REQUEST FOR BOARD ACTION

HENDERSON COUNTY PLANNING BOARD

Combined Master and Phase II Development Plan for Sentelle Grove

Combined Master and Phase II Development Plan Review for Sentelle Grove Major Subdivision (File #2007-M15)

Map A: CCP Future Land Use Map

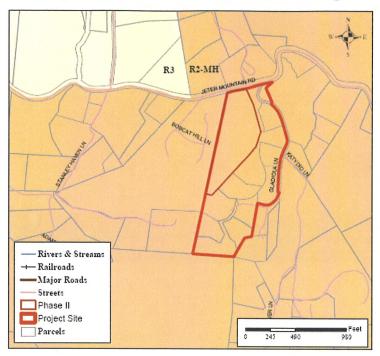
1. **County Comprehensive Plan (CCP).** The Future Land Use Map of the CCP shows the project site as being located within each of the following areas: Conservation Area and Rural Agricultural Area (RAA) (See Map A: CCP Future Land Use Map).

- Conservation Area. The conservation area designation is applied to the western portion of the project site, largely because of the presence of steep slopes in this area (See Map B: Slopes Map). The plan suggests that those lands recommended for conservation will be contained in Lot 11.

Map C: Draft Land Development Code Map

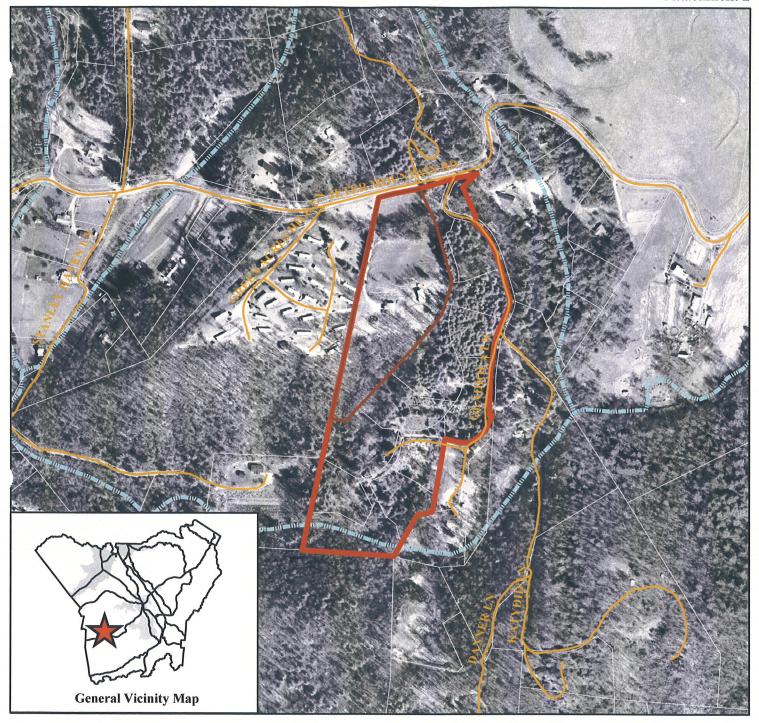
- 2. Land Development Code (LDC). According to Proposed Draft 8 of the Land Development Code Zoning Map the proposed project site for this development is located entirely in the Residential Zoning District 2 Manufactured Housing (R2MH) (See Map C: Draft Land Development Code Map). The current draft of the Land Development Code (LDC) allows for a density of one (1) unit per acre (average lot size of one (1) acre) for single-family residential development. According to the plan, the project would have an average density of 0.41 units per acre (average lot size of 1.40 acres). This would be in keeping with the densities generally proposed for the property by the Land Development Code, being that the proposed development is less dense than the LDC would allow. Since differences exist between proposed densities with the LDC and the CCP, if the LDC is adopted as proposed, the CCP may need to be amended to be consistent with the LDC.
